Technical Note TN-927

## Production Change to Link-1 in TM8100 Mobile Radios

8 October 2004

**Location of Link1 on the topside of the TM8100 PCB [Plan view]**

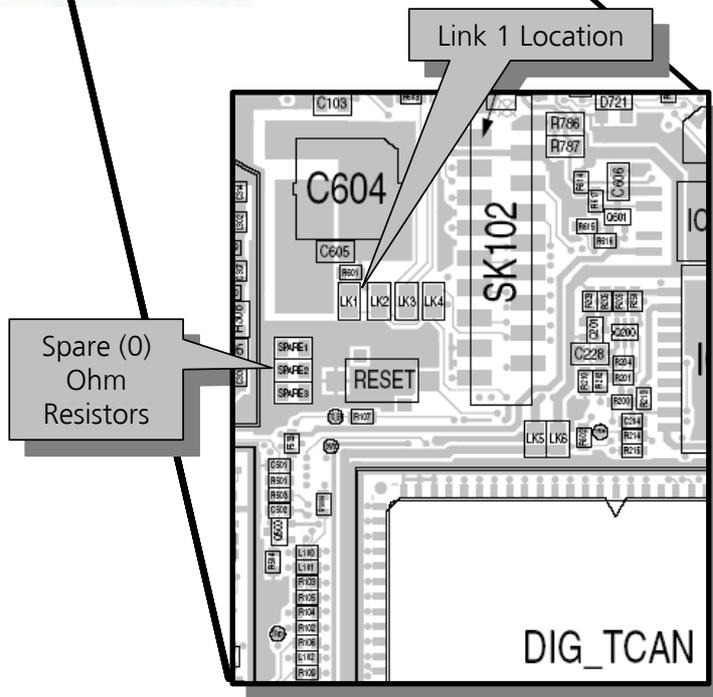
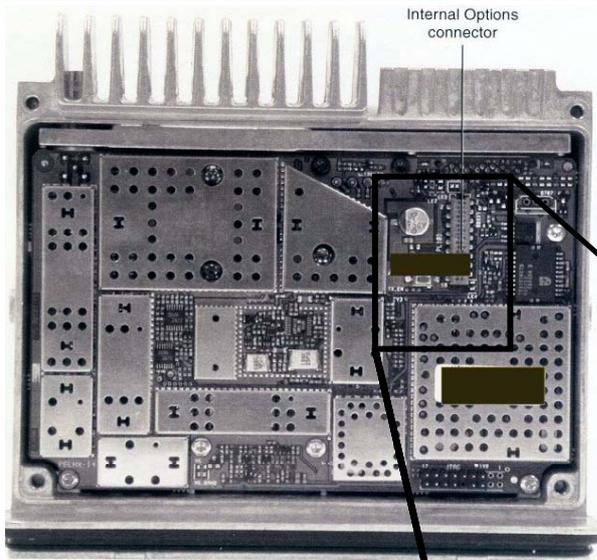
From July 5<sup>th</sup> 2004 all production builds of TM8100 radios had Link-1 removed as standard builds.

The change in production regarding Link 1 was taken after suggestions from CSO's, and their customers, who voiced their preference that the TM8110 / TM8115, in a standard mobile installation, would power off completely (to 1 mA) when done so from the control head on/off button.

Technical Support were subsequently made aware that in some installations a powered-up TM8100 would power-off because the DC potential dropped below 10.8V during engine cranking.

- With Link-1 fitted the TM8100 would power-on again as soon as the DC supply rose above 10.8V
- With Link-1 removed the TM8100 would stay off and require user operation to power the radio on again.

Concerns were also made that radios to be installed as blank head TM8105's would require dealers to open all of those radios to refit Link-1, thus adding time and effort to standard installations.

After consultation with CSO Technical Managers, agreement was made to revert production builds to include the zero  $\Omega$  resistor in Link-1.

First production TM8100 Serial Number without Link-1 fitted was **19015719** (5 July 2004).

First production TM8100 Serial Number with Link-1 fitted was **19021739** (23 September 2004).
